MONTGOMERY COUNTY PLANNING DEPARTMENT
THE MARYLAND-NATIONAL CAPITAL PARK AND PLANNING COMMISSION

MEMORANDUM

REVIEW TYPE: Preliminary Plan of Subdivision and Preliminary/Final Water Quality Plan

PROJECT NAME: Shirkey's Addition to Fairland Acres
CASE #: 120100110
REVIEW BASIS: Chapter 50, Montgomery County Subdivision Regulations

PRELIMINARY PLAN
SHIRKEY'S ADDITION TO FAIRLAND ACRES
 Montgomery County, Maryland

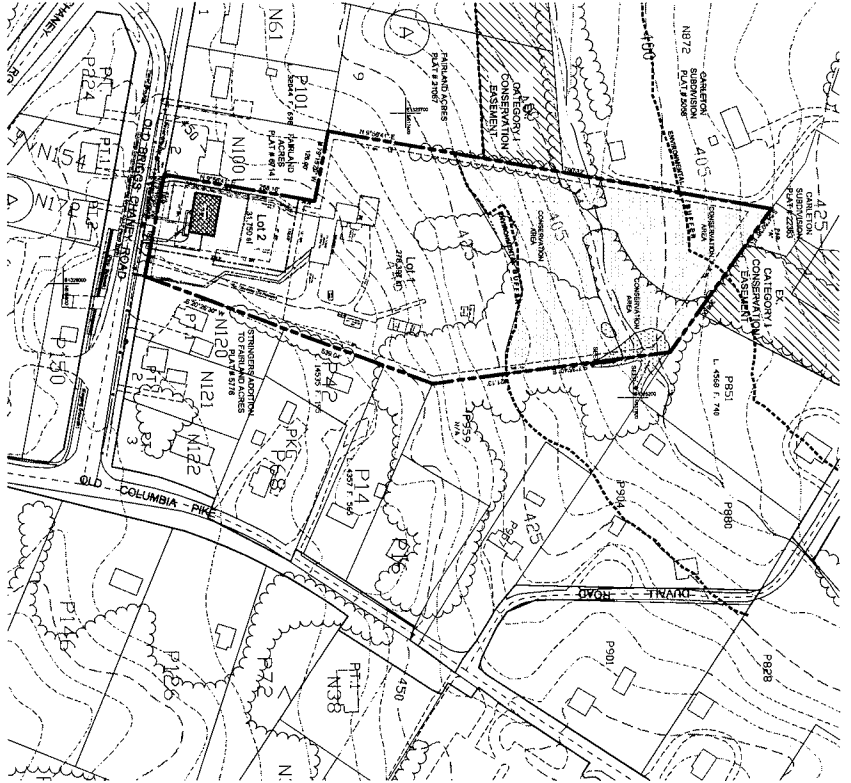
- 6) The applicant must satisfy MCDPS requirements prior to recordation of the plat to ensure the construction of a 182-foot long, five-foot-wide sidewalk along the south side of Old Briggs Chaney Road, from the terminus of the existing sidewalk west of the intersection with Old Columbia Pike.

The proposed clearing and grading for the new house will affect portions of the critical root zone for two relatively large trees on adjoining parcel N100: a 26.2-inch diameter at breast height (DBH) black cherry and a 24-inch DBH silver maple. The preliminary forest conservation plan shows that less than one-third of each tree’s critical root zone will be disturbed and that the trees will be retained. Staff recommends that the Final Forest Conservation Plan include specific tree preservation measures as part of a tree save plan for these two trees.
